RESPONSE TO THE CONSULTANT'S DESIGN REVIEW COMMENTS						DATE		22.03, 2025				
PROJECT NAME: The Project of the New Port of Caio in Cabinda												
MAIN SUBJECT: RESPONSE TO CONSULTANT'S DESIGN REVIEW COMMENTS RAD-CRBC-136 DD MAIN GATE_SE20250314 (ARCH PART)						SECTION OF PROJECT		LOT 1 LOT 2 LOT 3 OTHERS <input checked="" type="checkbox"/> <input type="checkbox"/> <input type="checkbox"/> <input type="checkbox"/>				
ROAD NETWORK	CIVIL	FIRE PROTECTION	ELECTRICAL	INSTRUMENT	STRUCTURAL	MECHANICAL PROCESS	HVAC	PLUMBING	GEOTECHNICAL	ESTIMATING	PROJECT	OTHER
<input type="checkbox"/>	<input type="checkbox"/>	<input type="checkbox"/>	<input checked="" type="checkbox"/>	<input type="checkbox"/>	<input checked="" type="checkbox"/>	<input type="checkbox"/>	<input checked="" type="checkbox"/>	<input checked="" type="checkbox"/>	<input type="checkbox"/>	<input type="checkbox"/>	<input type="checkbox"/>	<input type="checkbox"/>

PREPARED BY: DESIGN TEAM OF CRBC CAIOPORT PROJECT MANAGEMENT						REVIEW DOCUMENT REF. & DATE OF THE CONSULTANT		RAD-CRBC-136 DD MAIN GATE_SE20250314 (ARCH PART)				
REVIEWER BY: Gao Changsheng / CHIEF ENGINEER OF CRBC CAIOPORT PROJECT MANAGEMENT						CONTRACTOR'

2.- coordinate the rainwater dropdown pipes with LOT1_DD_1020-A-04

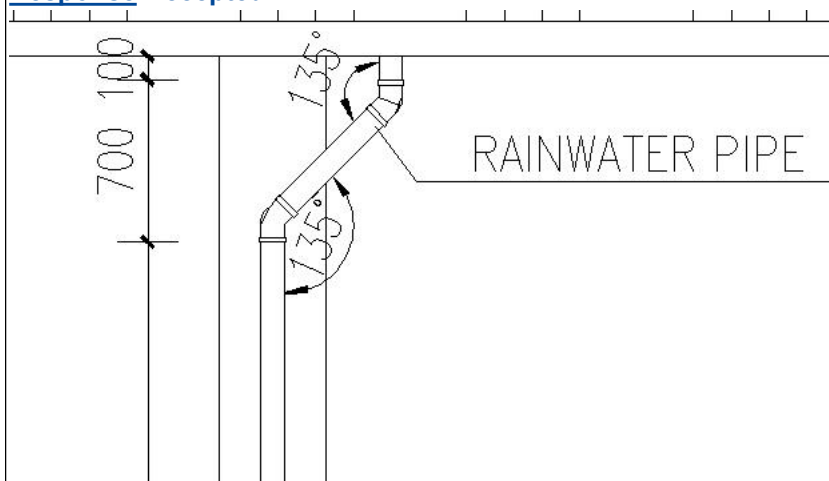
- detail the system

Response:Accepted.Rainwater system have already been supplemented.

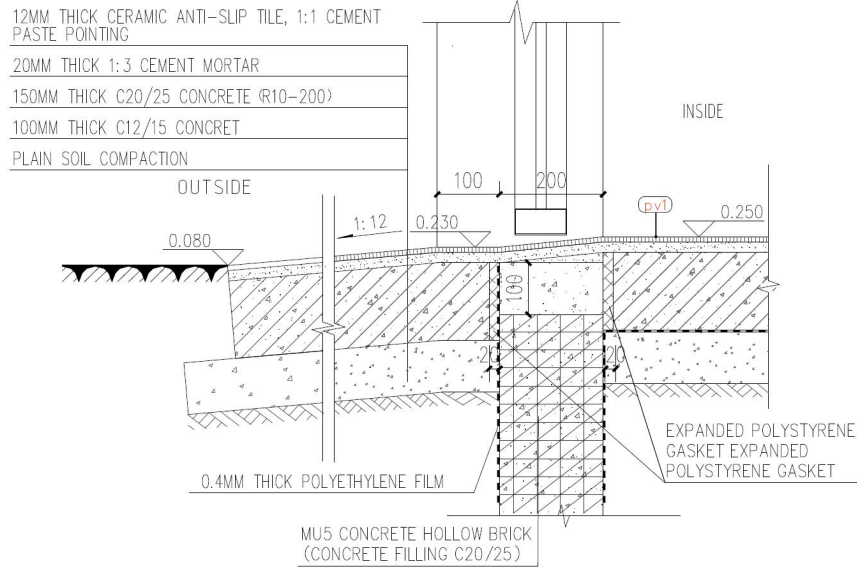
2. ramp detail?

Response: Accepted.The ramp details have already been supplemented.

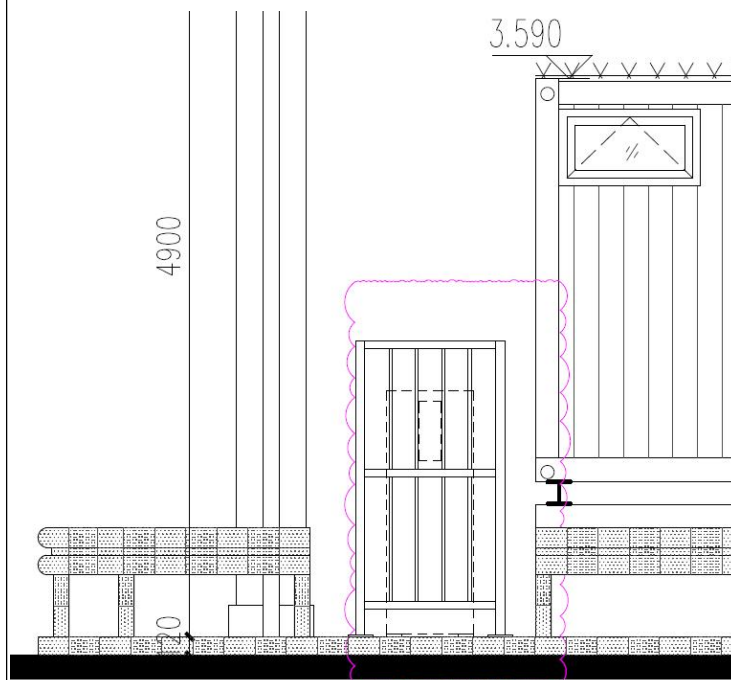
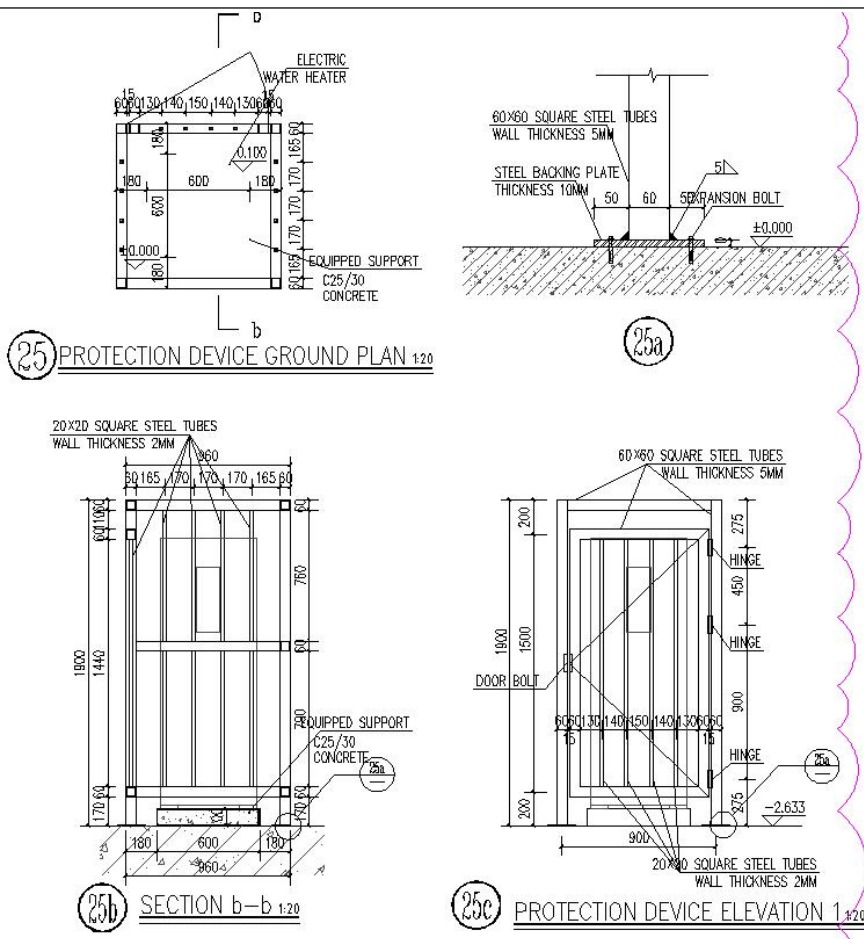
4. Water heaters? Supports, protection, details?

Response: Accepted. The water heaters and details have already been supplemented. And Reserve Water heaters refer to Plumbing drawings.

LOT1_DD_1020-A-04

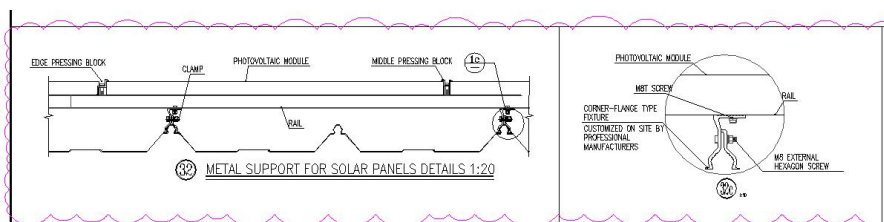
1.Details for photovoltaic system:supports/dimensions/penetration sealing

Response: Clarification, The drawings of metal support for solar panels will be prepared and detailed by the supplier, and its metal components should meet the c5 corrosion resistance requirements, with thickness of anti-corrosion paint $\geq 240 \mu\text{m}$. Fasteners should be effectively secured and firmly fixed. The waterproof level and performance of sealing components of solar supports should be consistent with that of the roof, and the original waterproof system should not be damaged.

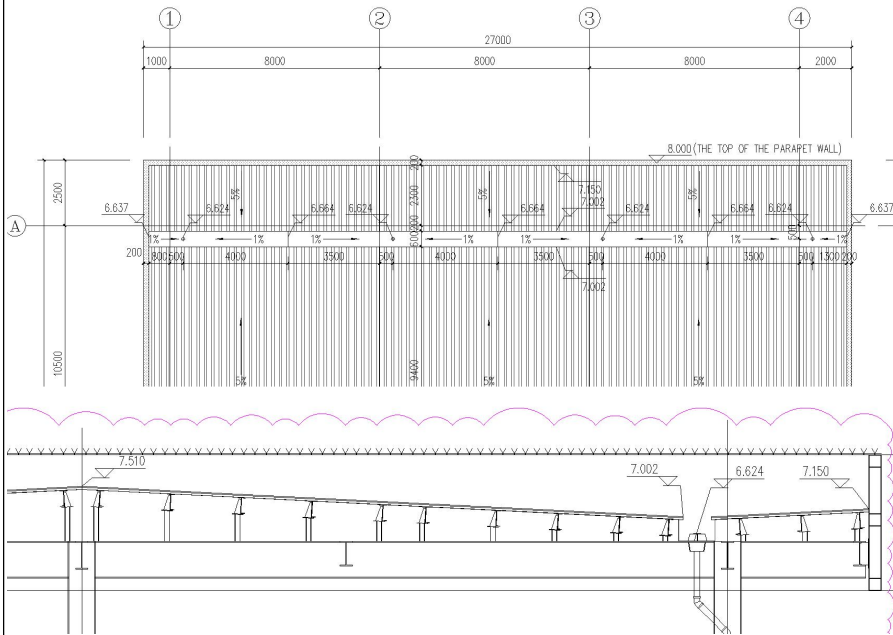
2.Dimensions? Elevations? (please refer to all relevant elements not only to the indicated ones)

Response: Accepted.Dimensions and Elevations and have already been supplemented in “DRAINAGE OUTBOUND PLAN” LOT1_DD_1020-A-04-1 and “SECTION 1-1”

LOT1_DD_
1020-A-05

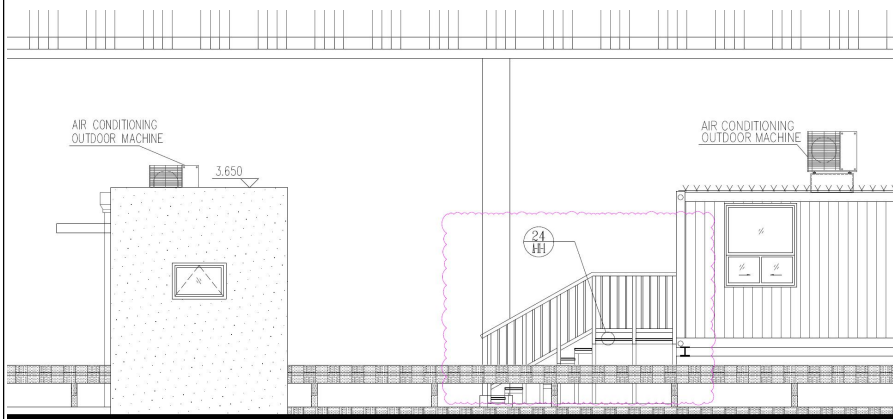
2.AC unit? details,penetrations, sealing?

Response: Accepted.AC unit details have already been supplemented. And Reserve pipeline hole refer to hvac drawings.

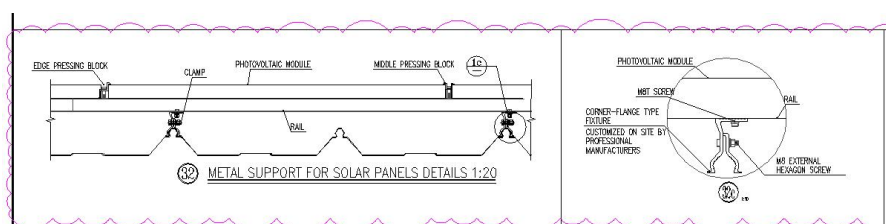
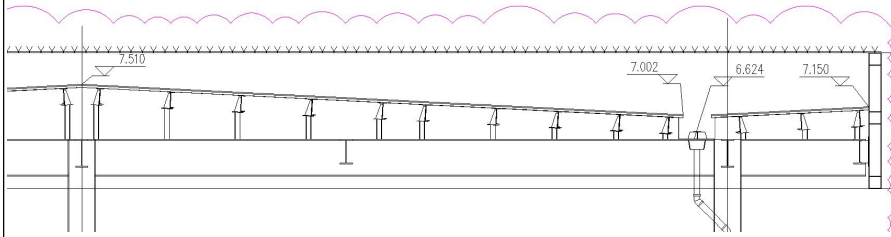
2.Details for pfotovoltaic system:supports/dimensions/penetration sealing

Response: Clarification, The drawings of metal support for solar panels will be prepared and detailed by the supplier, and its metal components should meet the c5 corrosion resistance requirements, with thickness of anti-corrosion paint ndft $\geq 240 \mu\text{m}$. Fasteners should be effectively secured and firmly fixed. The waterproof level and performance of sealing components of solar supports should be consistent with that of the roof, and the original waterproof system should not be damaged.

LOT1_DD_1020-A-011

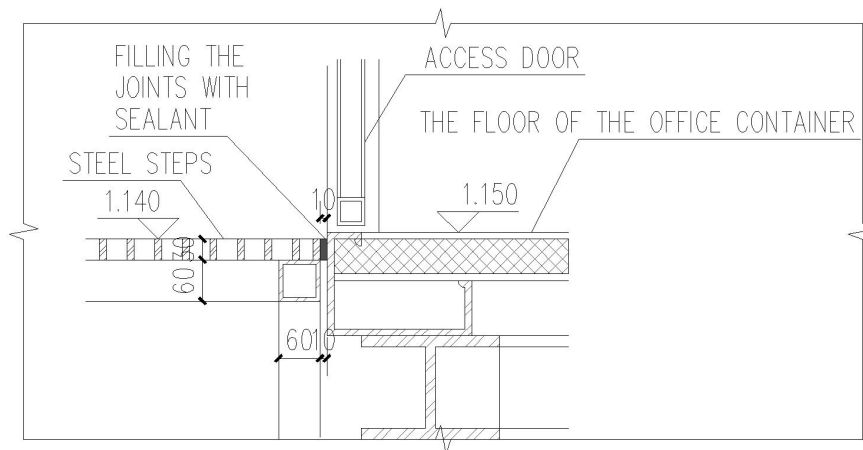
1. threshold detail missing

Response: Accepted.It has already been supplemented.

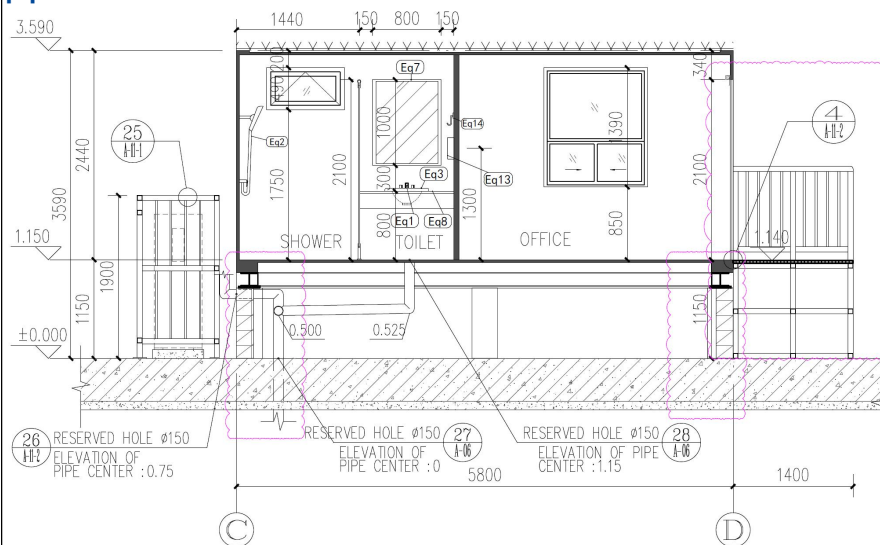
4.protection/concealing?

Response:Accepted.Build walls on all four sides to protect the pipes.

LOT1_DD_
1020-A-13

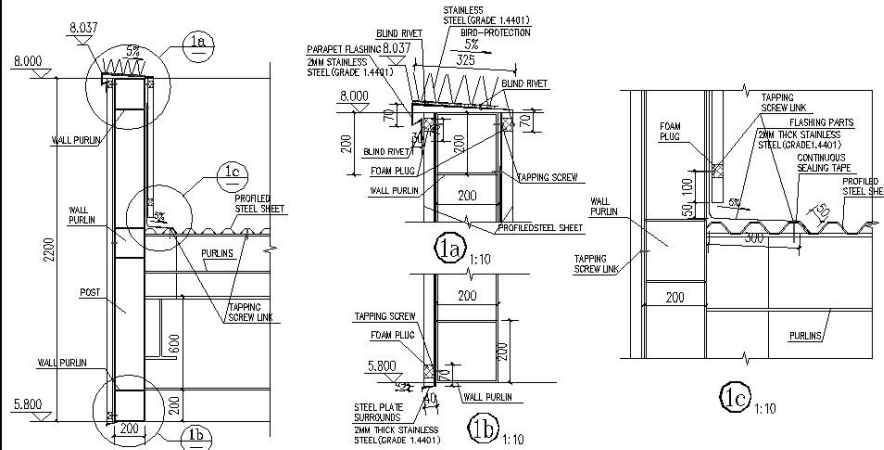
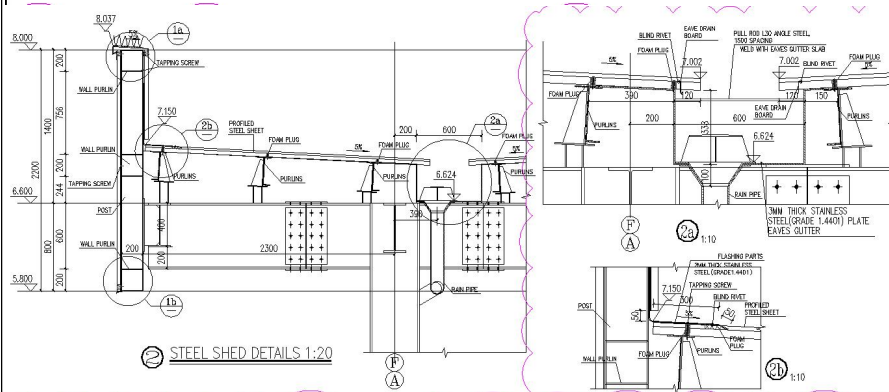
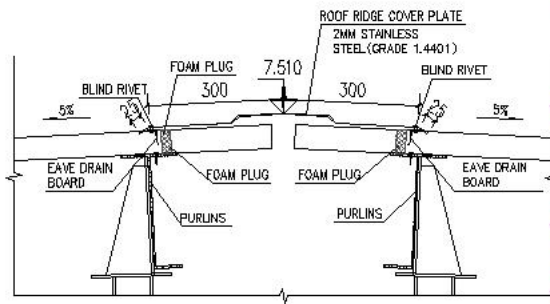
1. The details are general and not sufficient for this level of design

Response: Accepted.Supplement the detailed drawing information.

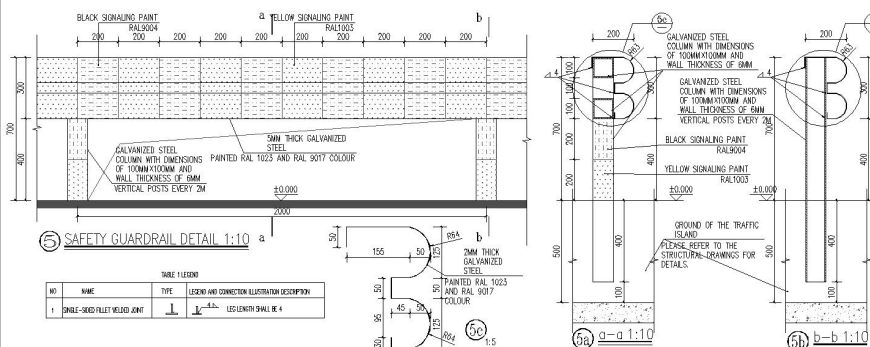
2. detailed drawings of the system missing

Response: Accepted. Safety Rails detailed drawings has been supplemented in LOT1_DD_1020-A-11-2.

<p>RAINWATER OUTLET OF ROOF</p>  <p>NOTE: ROOF DRAINS OUTLET CONSIST OF STAINLESS STEEL (GRADE 1.4401) GRATE AND MEMBRANE FLASHING CLAMP.</p> <p>12 1:10</p>	
<p>LOT1_DD_1020-A-14</p>	<p>serie 3603 turn and tilt window</p> <p>Response: Accepted.It has been revised.</p>	A

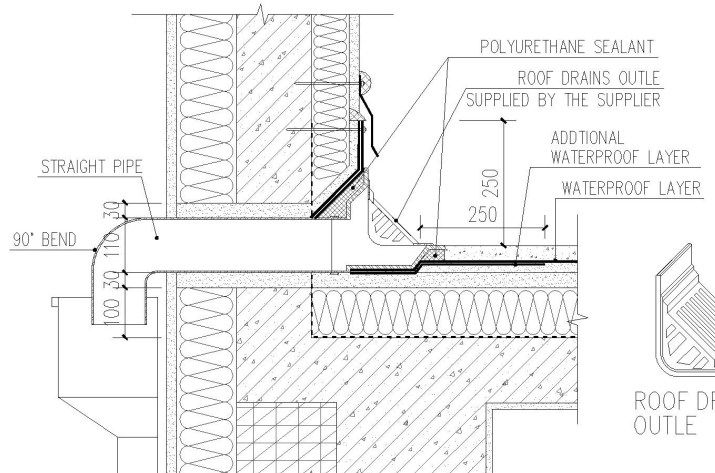
6.weak spot in regards of waterproofing. interface between waterproofing layers and rain outlet to be rechecked

Response: Accepted.Revise the detailed drawing.

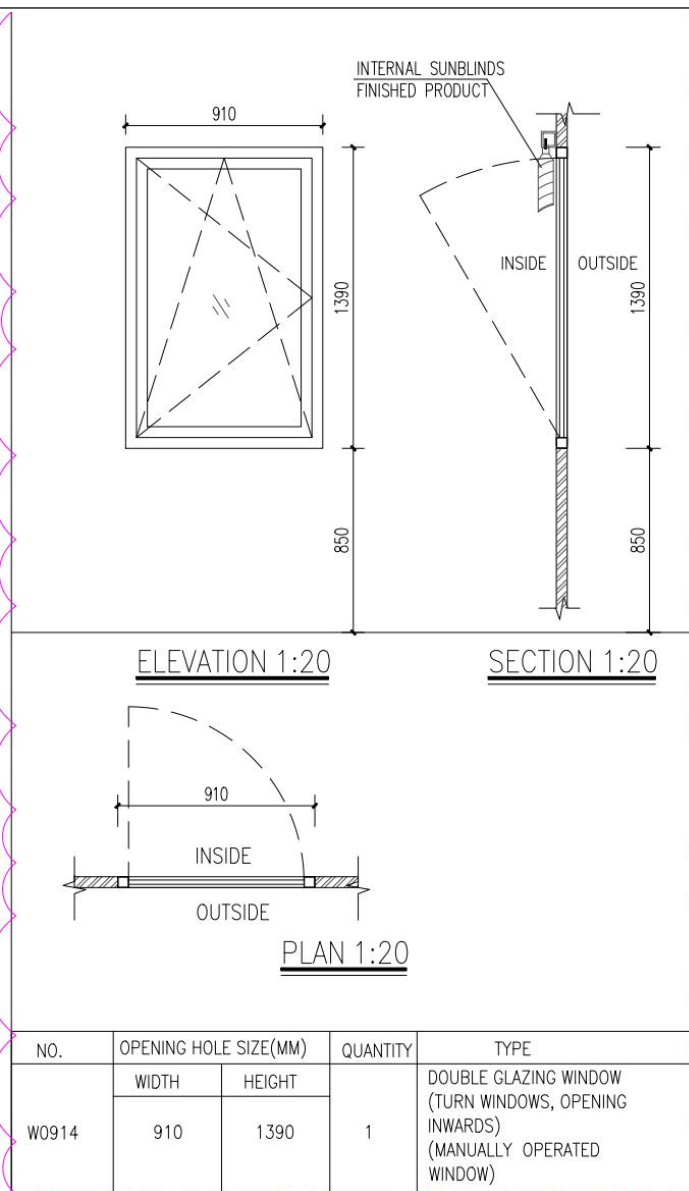
include Serie 3300 and 3600 Deviations should be listed in the description

Response: Accepted. It had been added.
